**PROJECT:**  
Wayside Bridge Repairs  
Wayside Inn Road  
Sudbury, MA 01776  
Project No. 2024-WSIB-1

**ADDENDUM NO. 2 04/30/2024**

- Replace the following drawings in their entirety. (See attached)  
S-103 Wayside Inn Bridge Repair Plan & Section

**STRUCTURAL WAYSIDE INN BRIDGE REPAIR PLAN & SECTION**

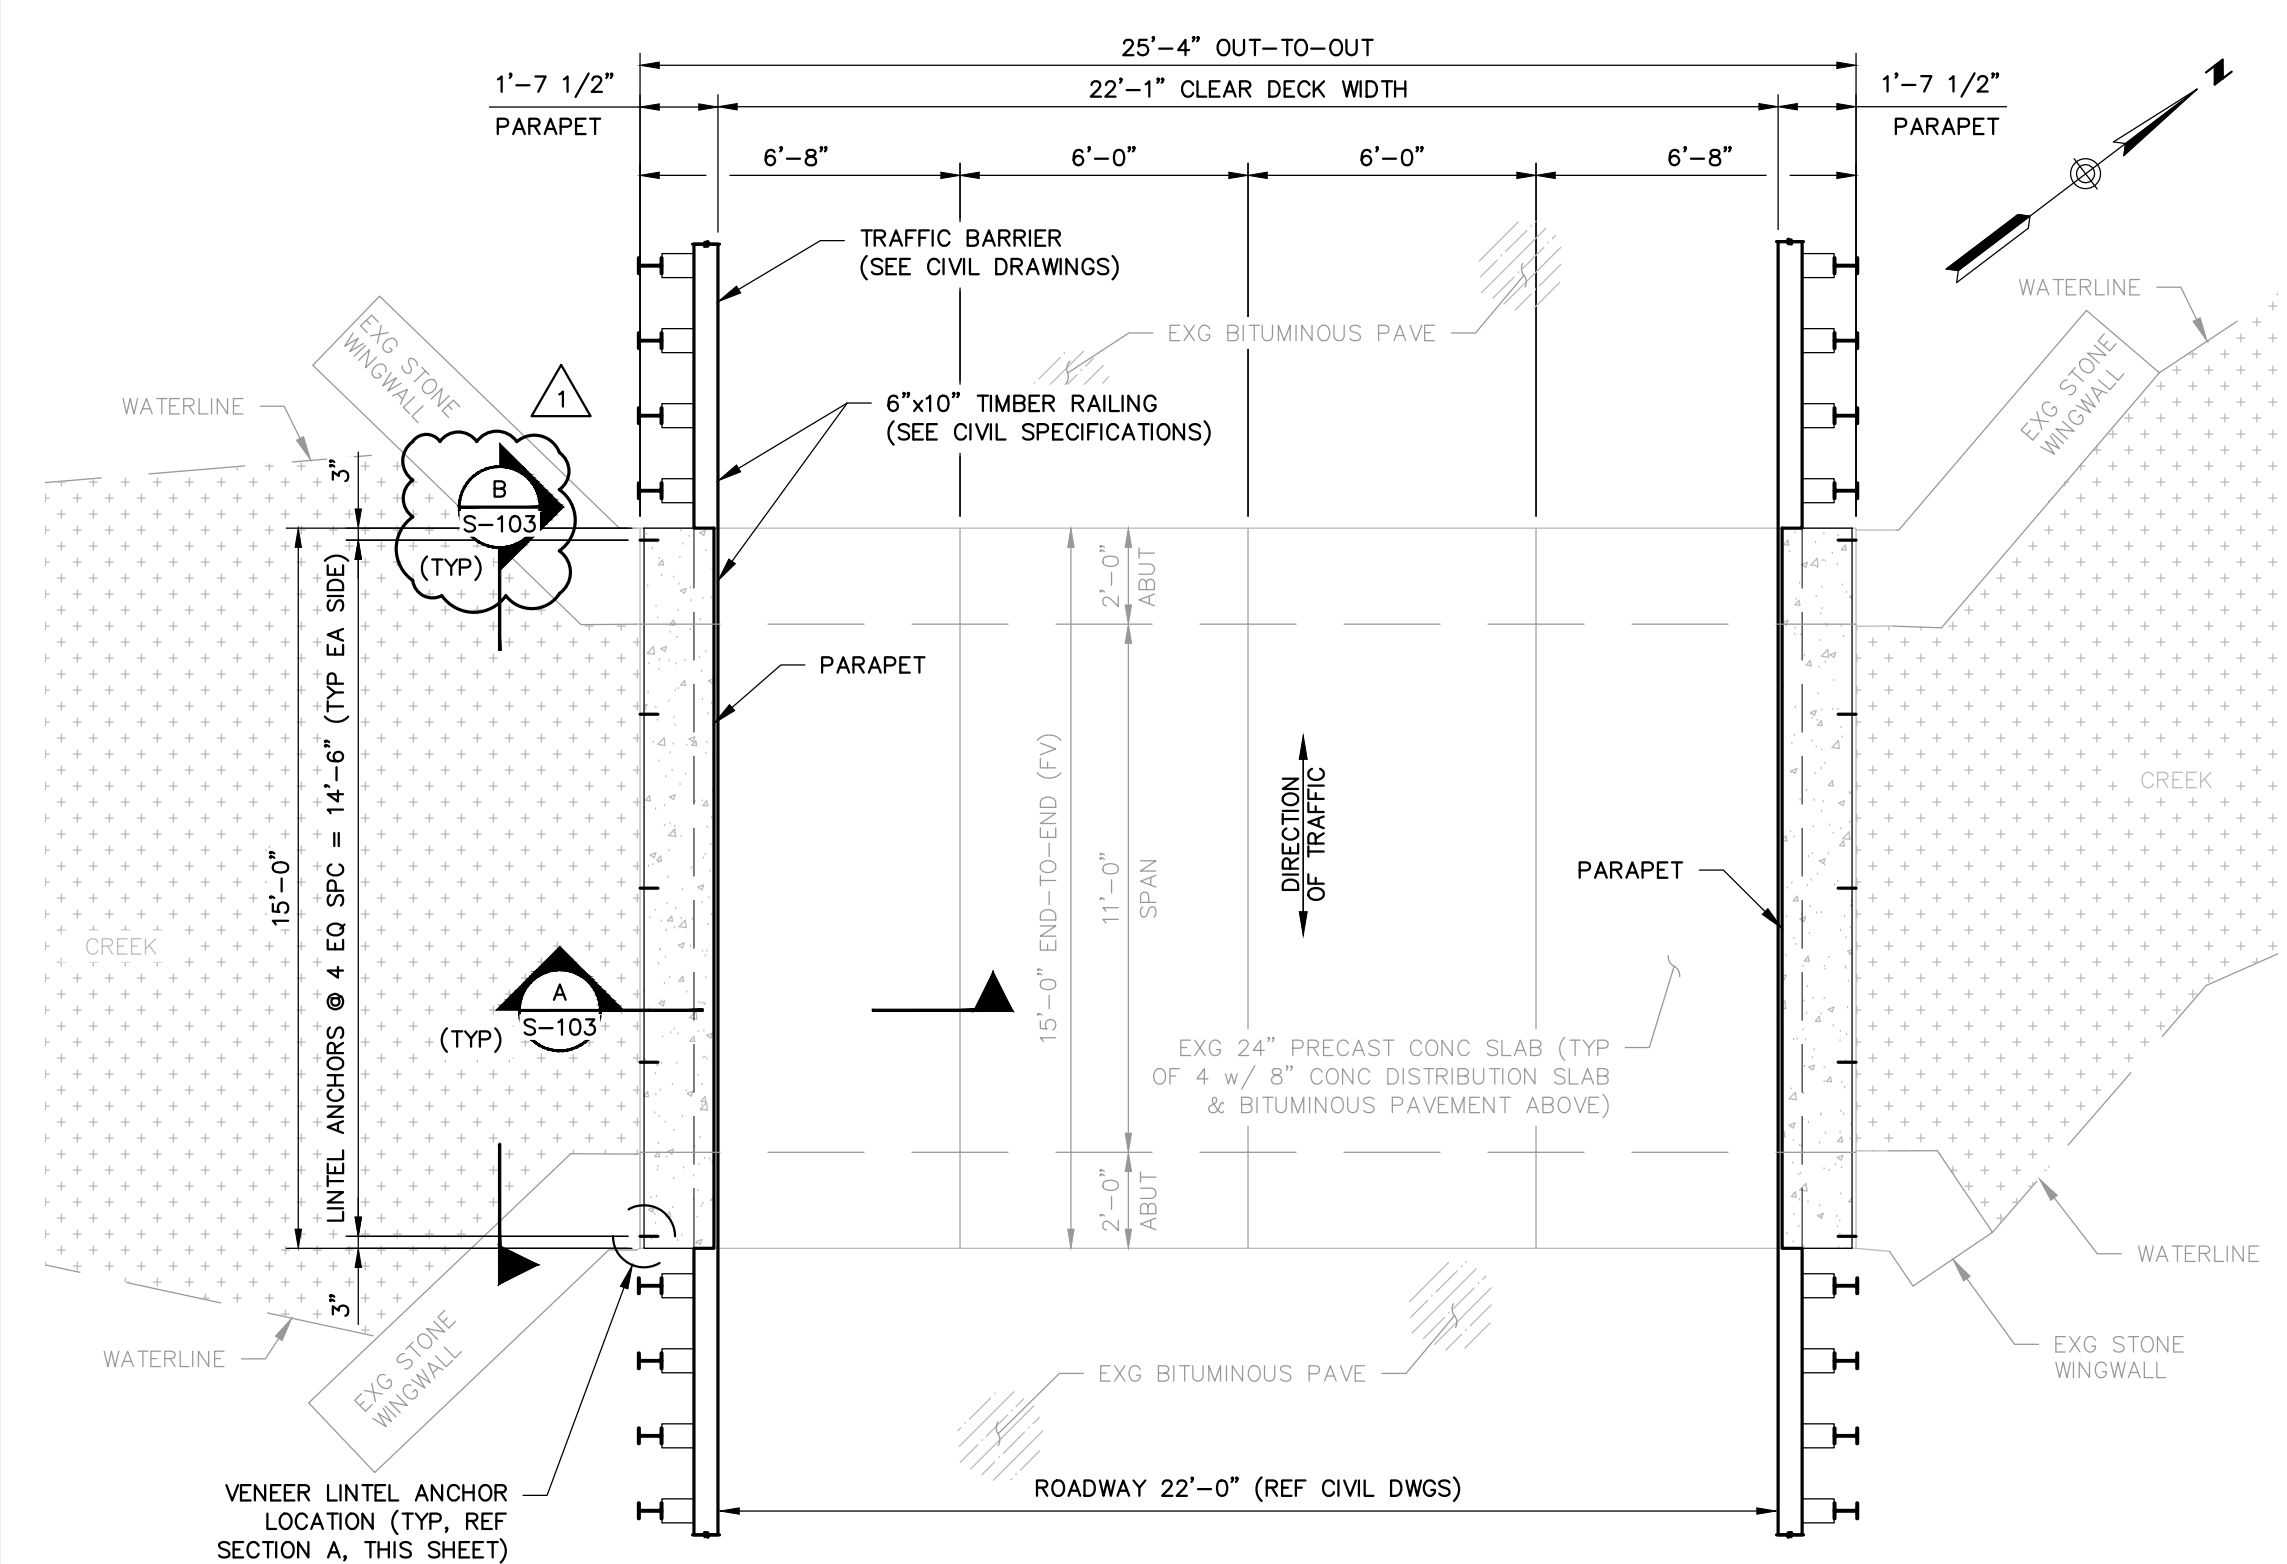
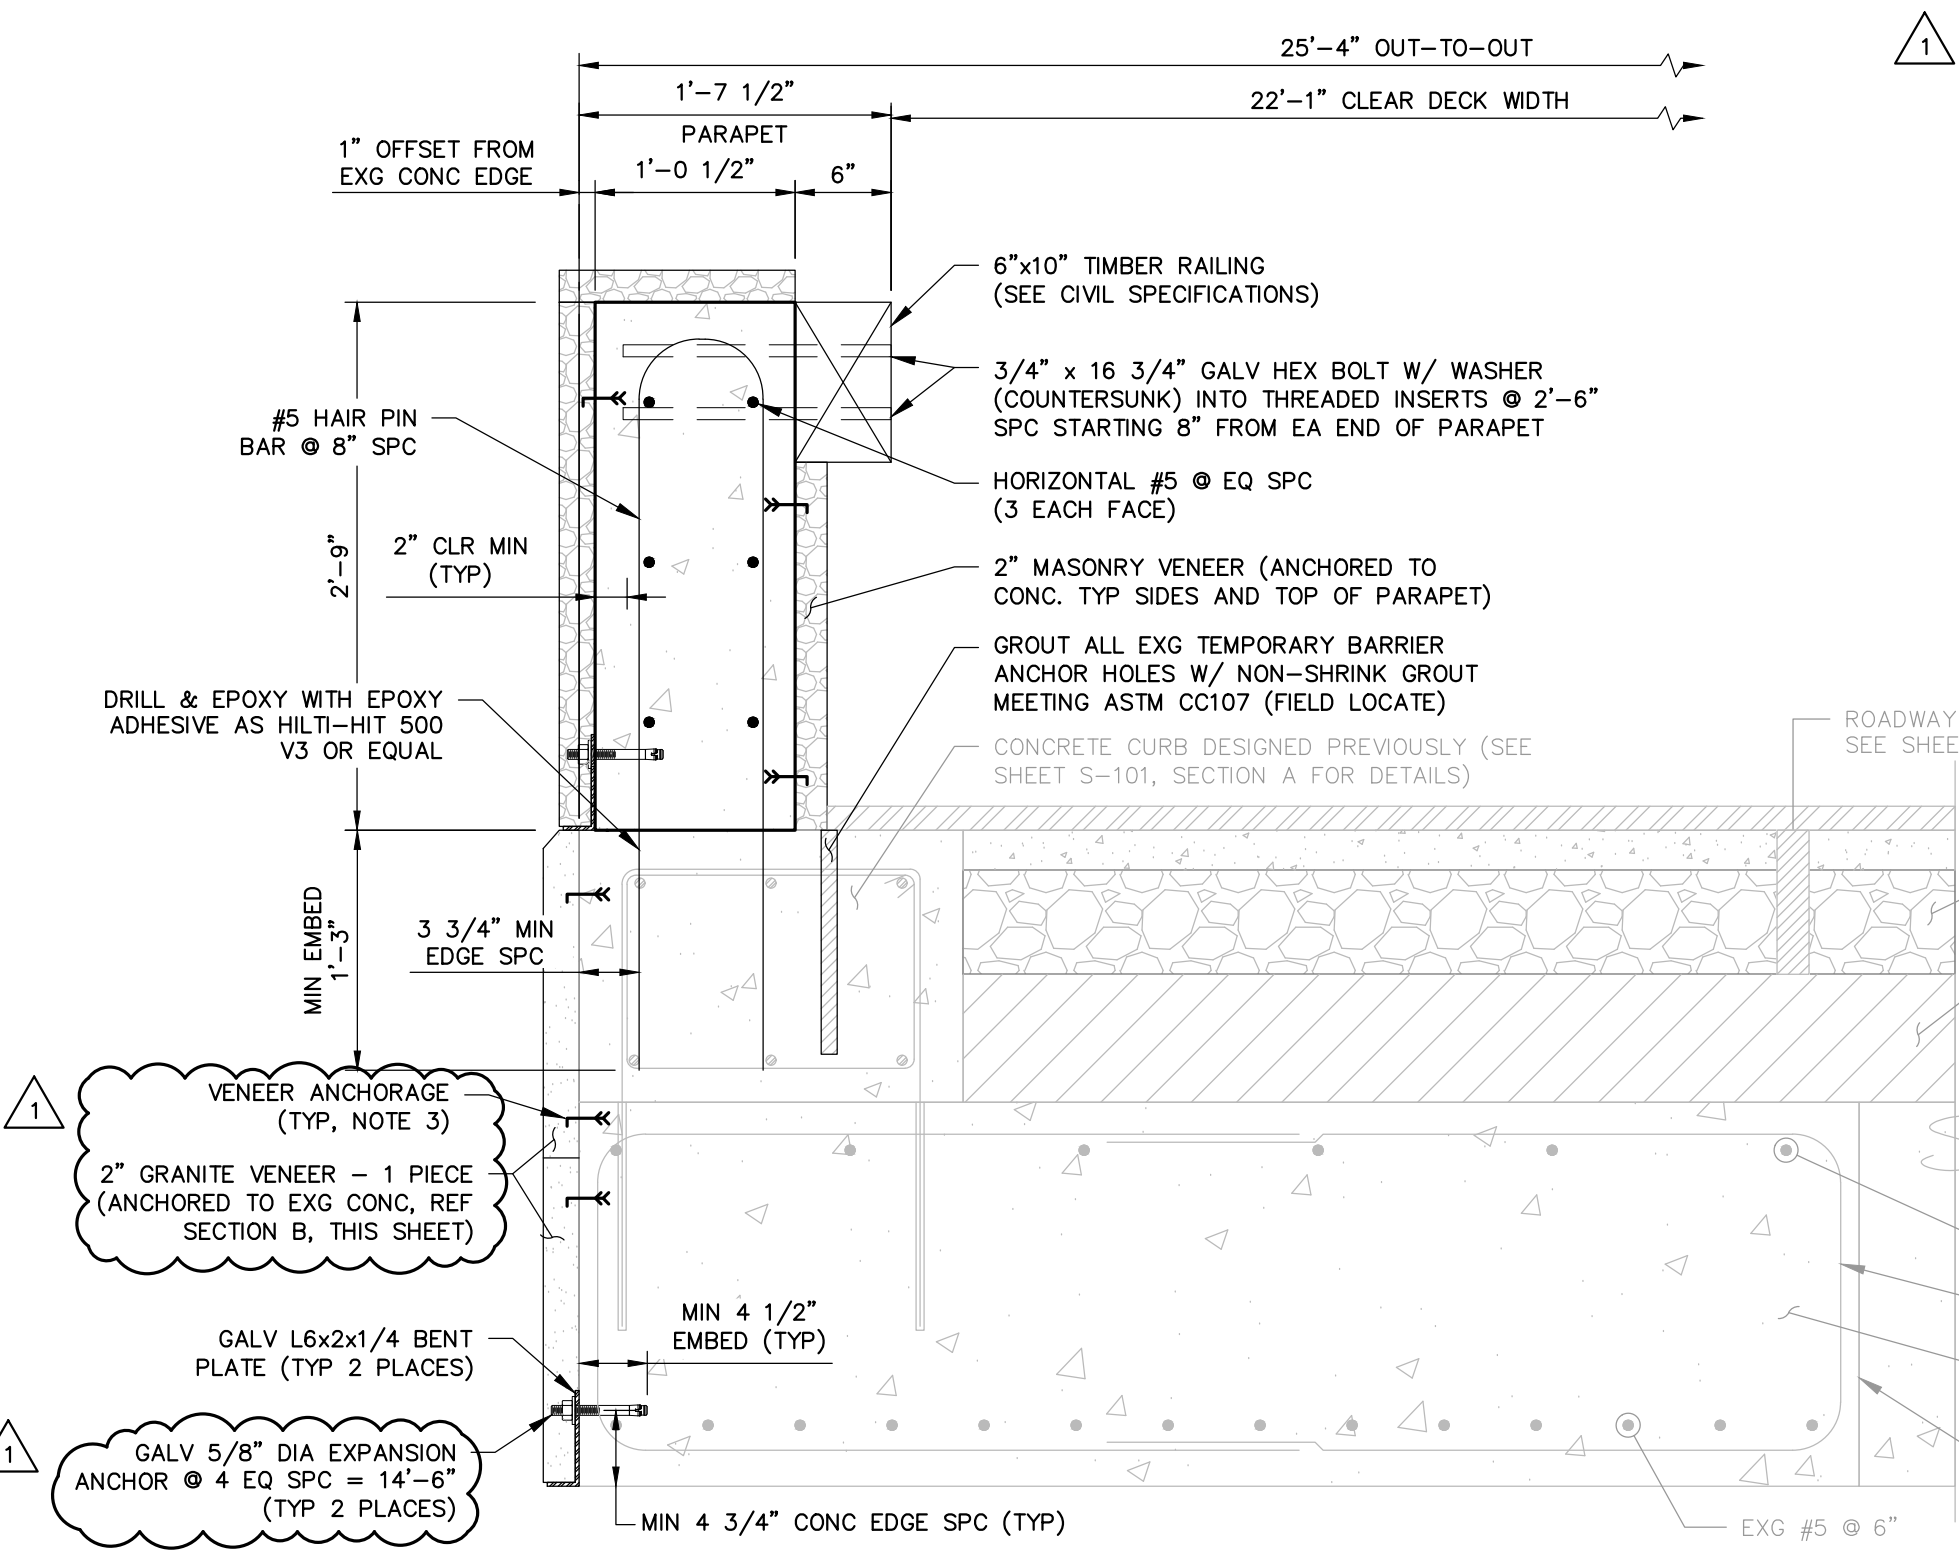
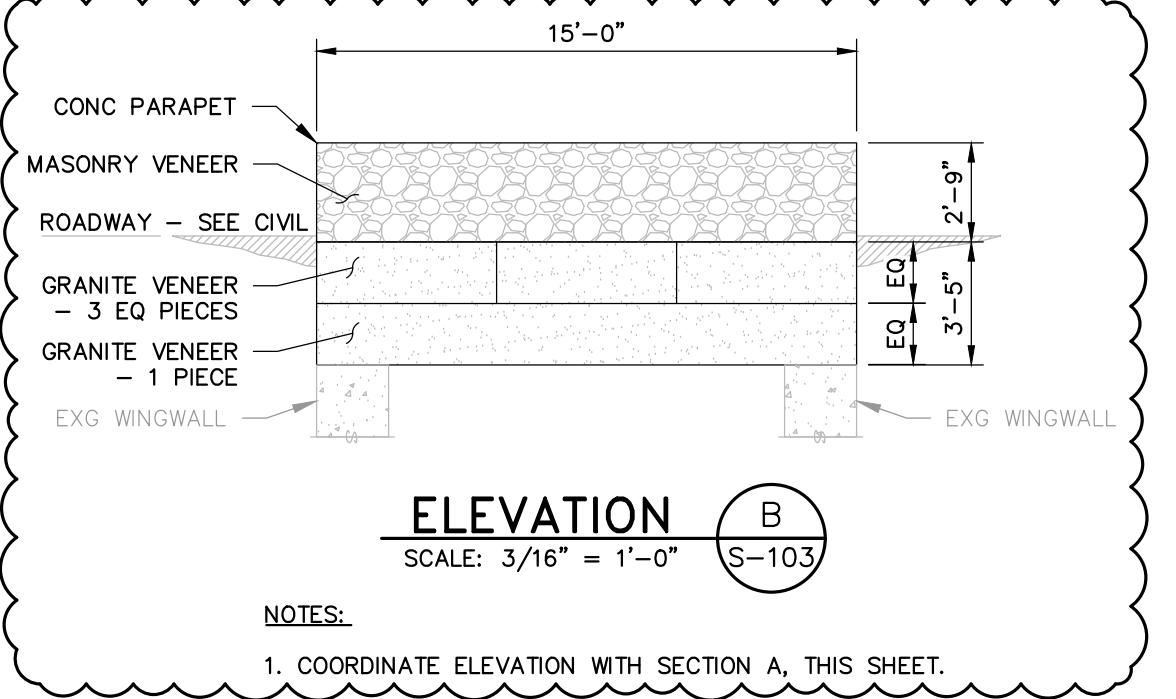
REV	MM/DD/YY	DESCRIPTION
1	04/29/24	UPDATED VENEER DESIGN AND NEW ELEVATION
0	04/10/24	ISSUE FOR BID
